**RE: DA REFERENCE DA-1443/2016 JRPP REF 2016HCC055 – PROPOSED SENIORS HOUSING – 14 HALYARD WAY, BELMONT**

## ATTACHMENT 2 – AMENDED LAYOUT FOOTPRINT

PROPOSED SENIORS LIVING VILLAGE LAYOUT  
SITE ANALYSIS PLAN  
Lot 803 DP1156934  
14 HALYARD WAY, BELMONT

PROPOSED SENIORS LIVING VILLAGE LAYOUT  
DETAILED LAYOUT PLAN  
Lot 803 DP1156934  
14 HALYARD WAY, BELMONT

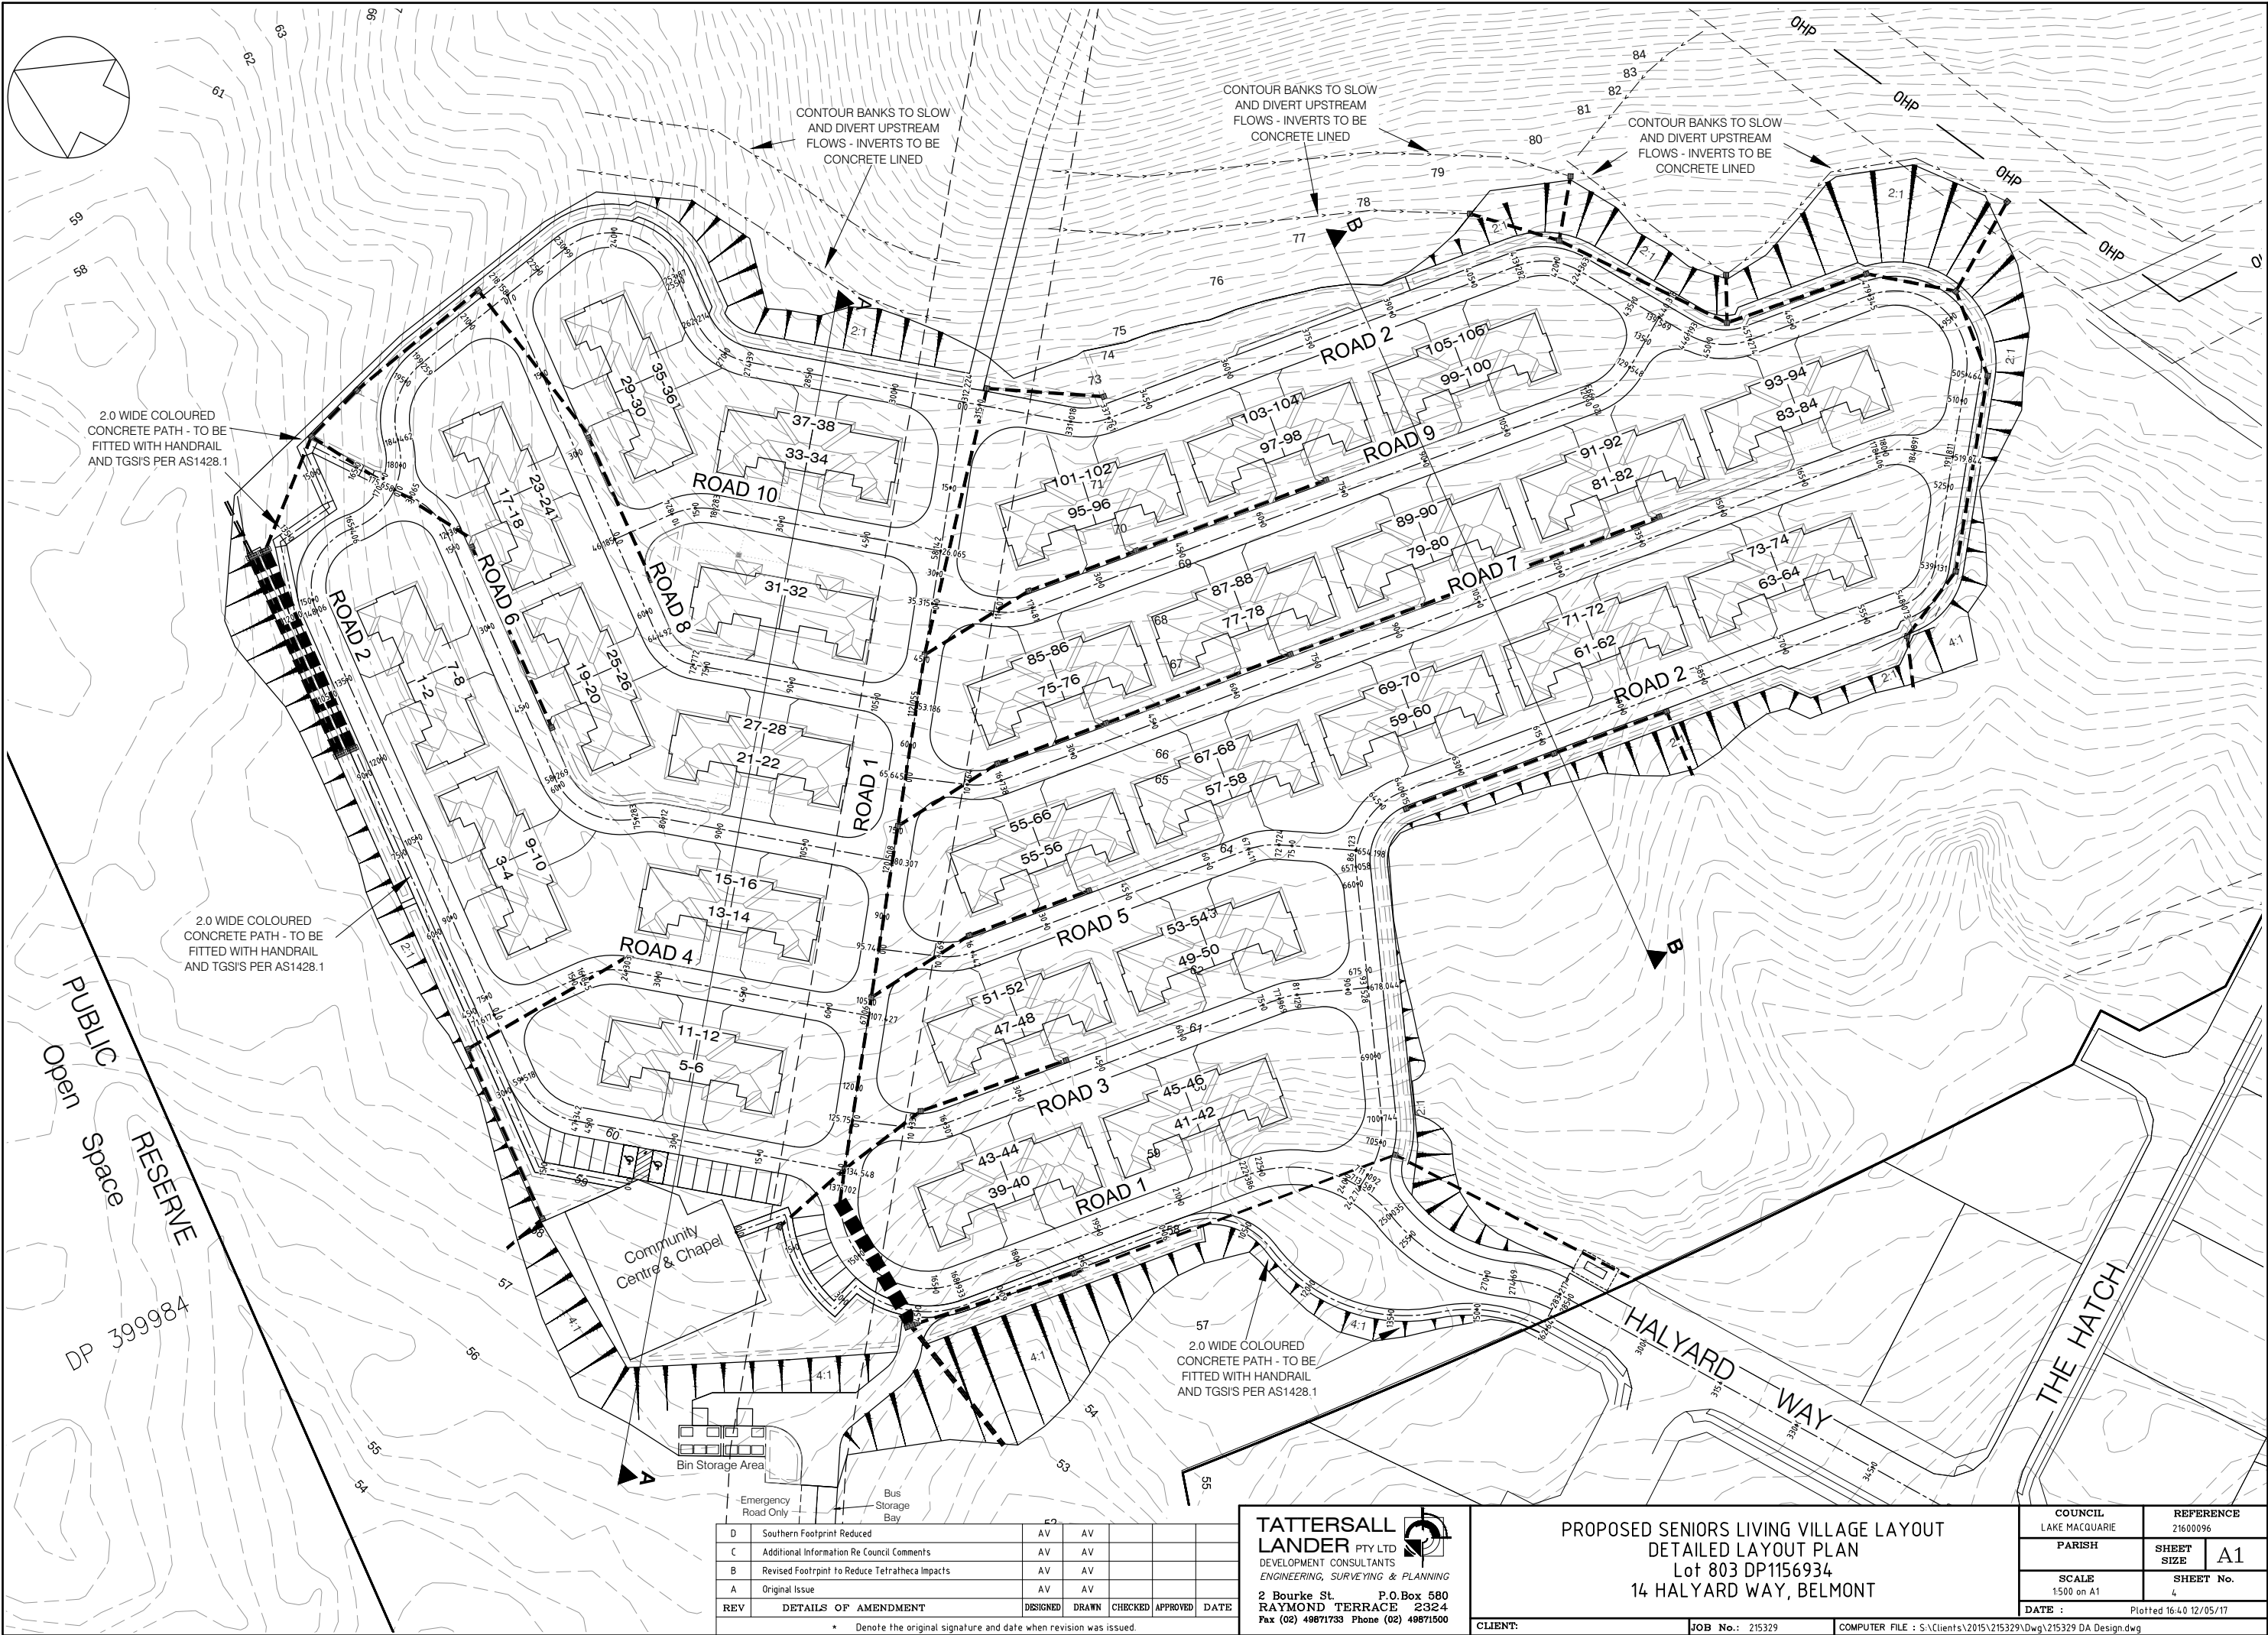
| D   | Southern Footprint Reduced                    | AV       | AV    |         |          |      |
| C   | Additional Information Re Council Comments    | AV       | AV    |         |          |      |
| B   | Revised Footprint to Reduce Tetraheca Impacts | AV       | AV    |         |          |      |

In regard to the 2:1 batters, runoff from upstream catchments to be intercepted/diverted via contour drains (see Sheet 4 of design plans). These have now been further expanded to the south around the largest cut batter and the details will be included in the amended planset.

It is true that the contributing catchment is increased (up to 2.63Ha), but significant detention is also proposed in this catchment with large underground tanks and cross linked low flow to Catchment D (seen on Sheet 4 of Design Plans) that will actually reduce the peak discharge rates. All waters will also have been appropriately treated by the WSUD treatment train, so no detrimental impacts are expected.
